Commonwealth Edison Company  
Byron/Braidwood Units 1 and 2  
Relaxation of MSSV Setpoint Tolerance to +/-3% - Revised SECL

Enclosed please find Revision 1 to safety evaluation SECL 90-469, previously transmitted via Reference 1. The revised safety evaluation clarifies the section of the ASME code associated with the main steam safety valves.

WESTINGHOUSE NUCLEAR SAFETY  
SAFETY EVALUATION CHECK LIST

APPENDIX B  
UFSAR MARKUPS

FIGURE 15.2-1

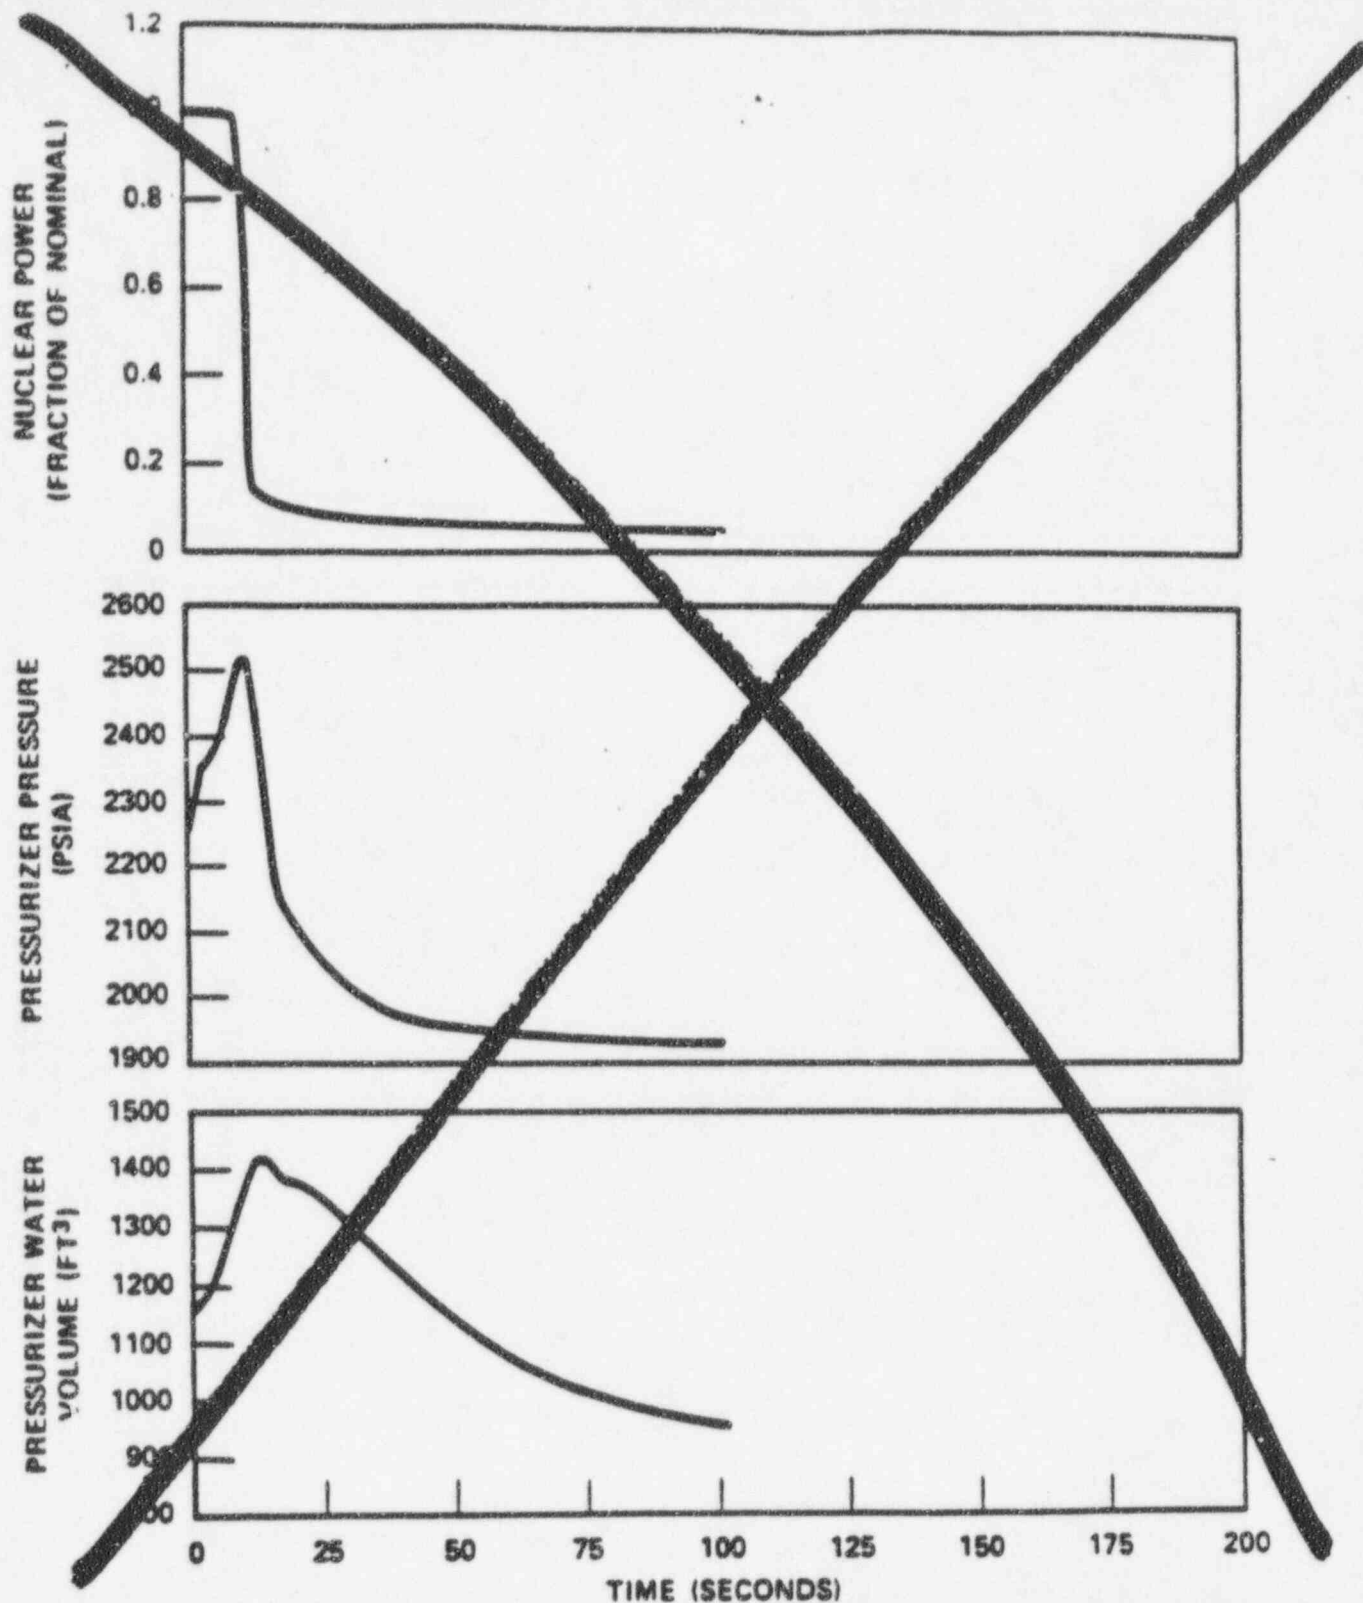
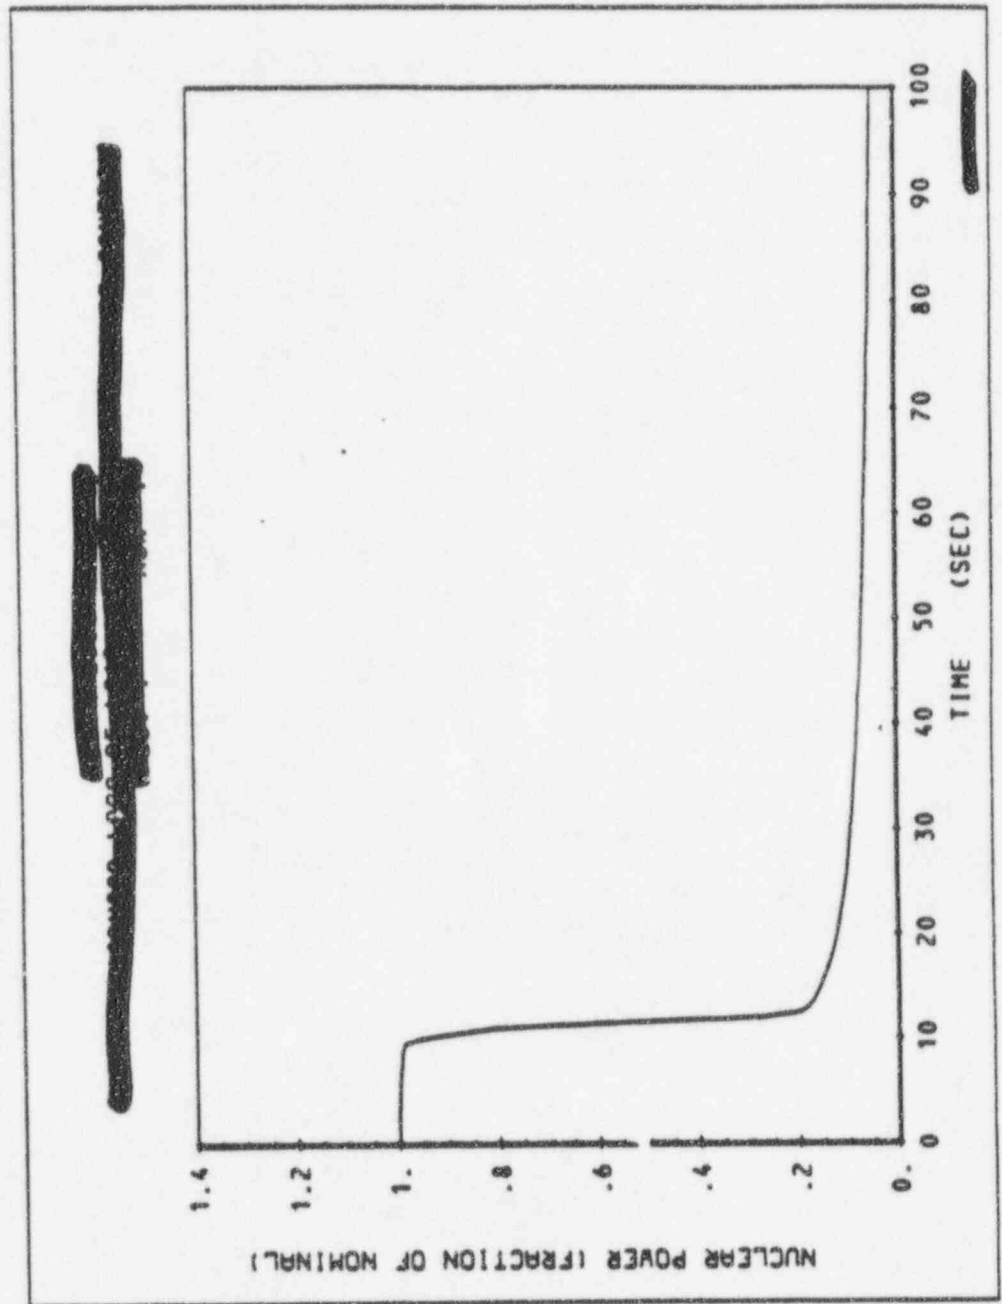
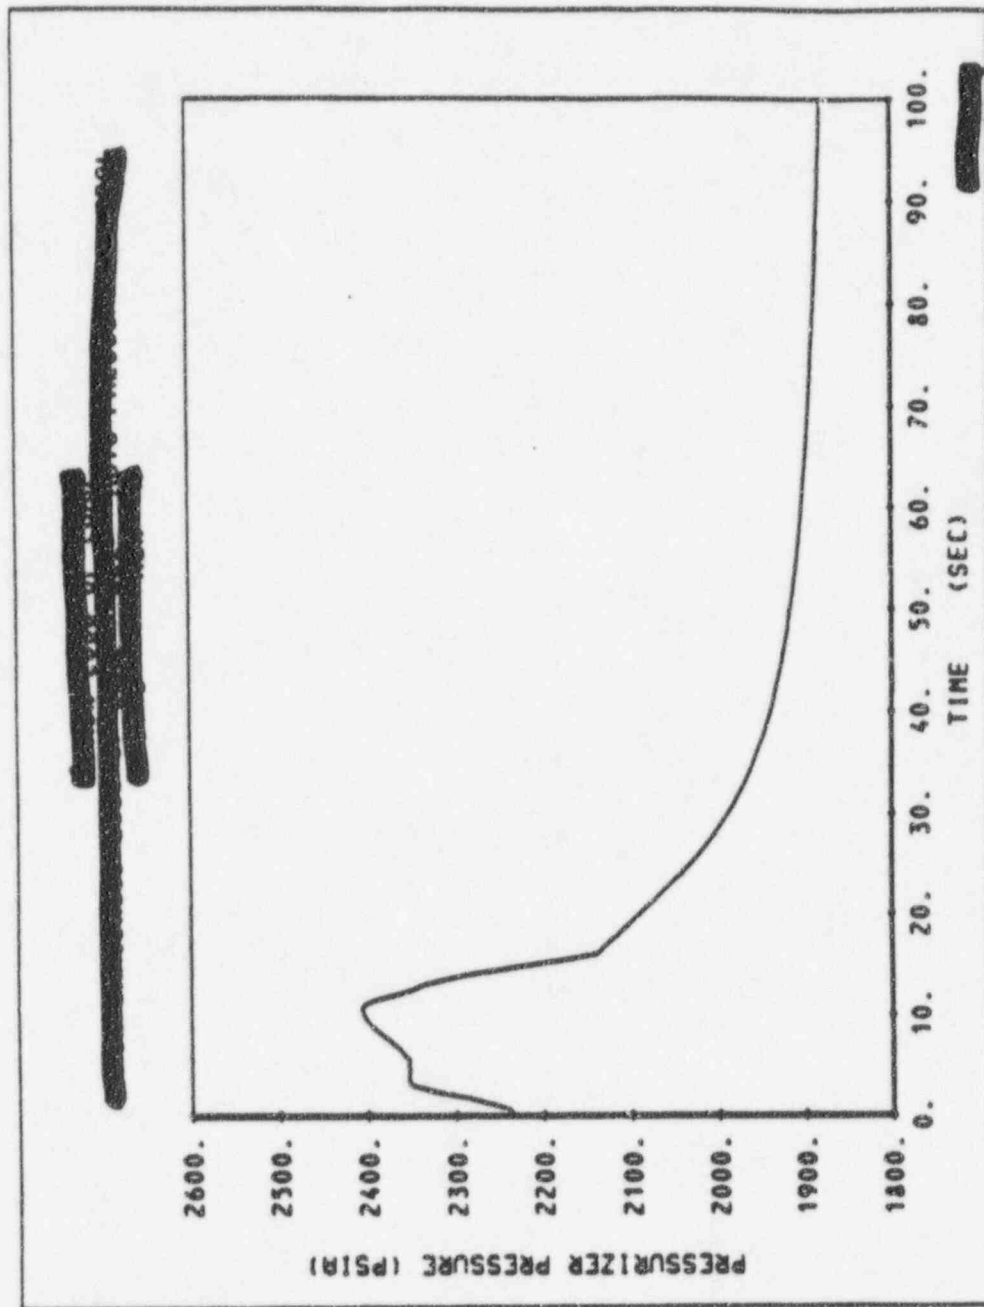
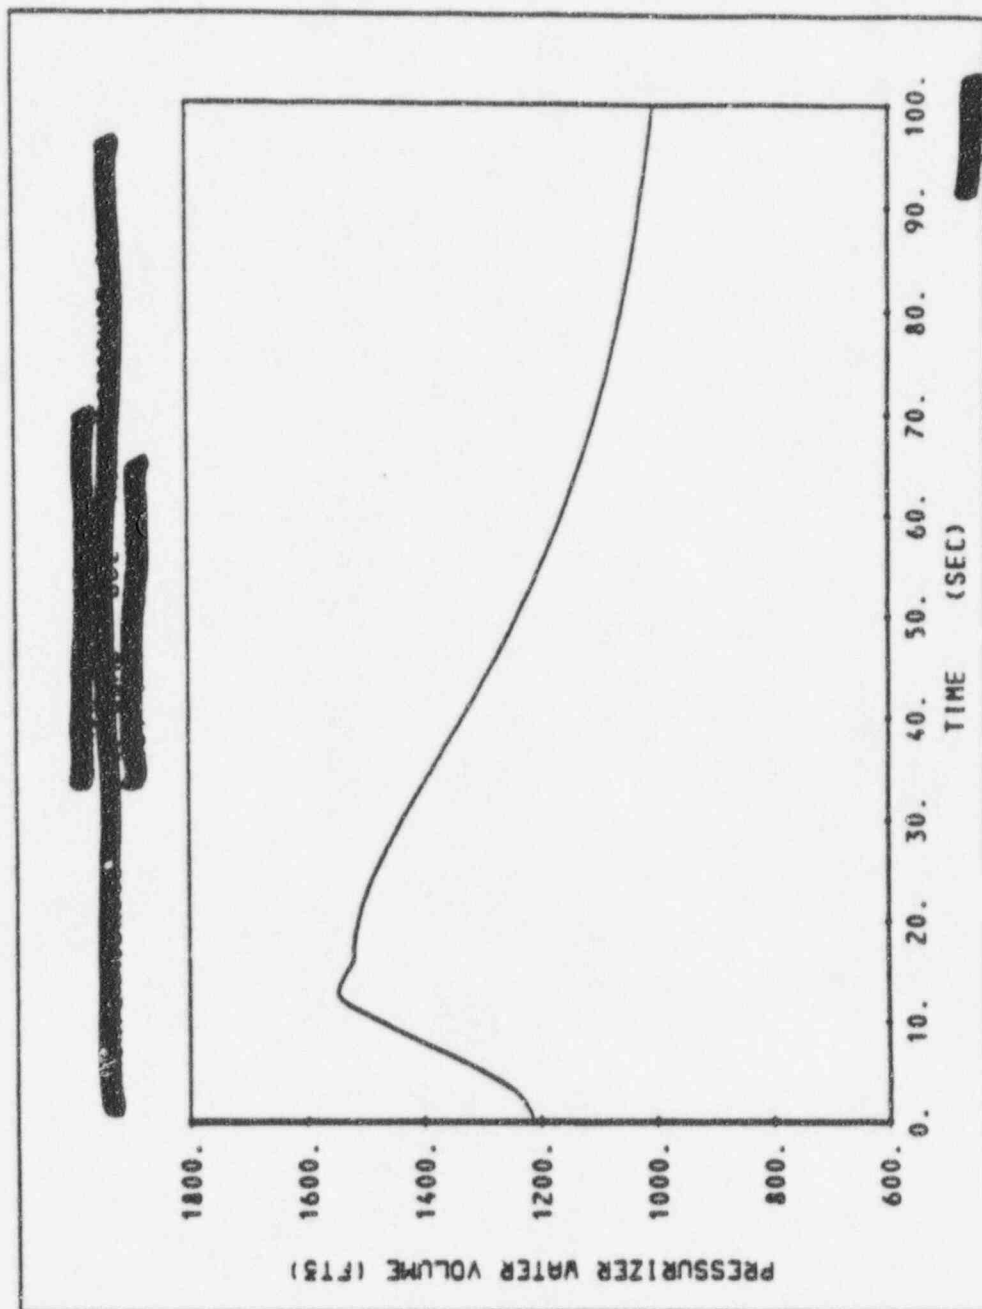
Figures 15.2-1 and 15.2-2 show the transient responses for the total loss of steam load with a least negative moderator temperature coefficient assuming full credit for the pressurizer spray and pressurizer power-operated relief valves. No credit is taken for the steam dump. The reactor is tripped by the ~~high-pressurizer pressure~~ trip channel. The minimum DNBR remains well above the limit value. The pressurizer ~~safety valves~~ are actuated and the primary system pressure remains below the 110% design value. The steam generator safety valves limit the secondary steam ~~conditions to saturation at the safety valve setpoint.~~ pressure to less than 110% of the design value.

REPLACE WITH  
The following  
Figures
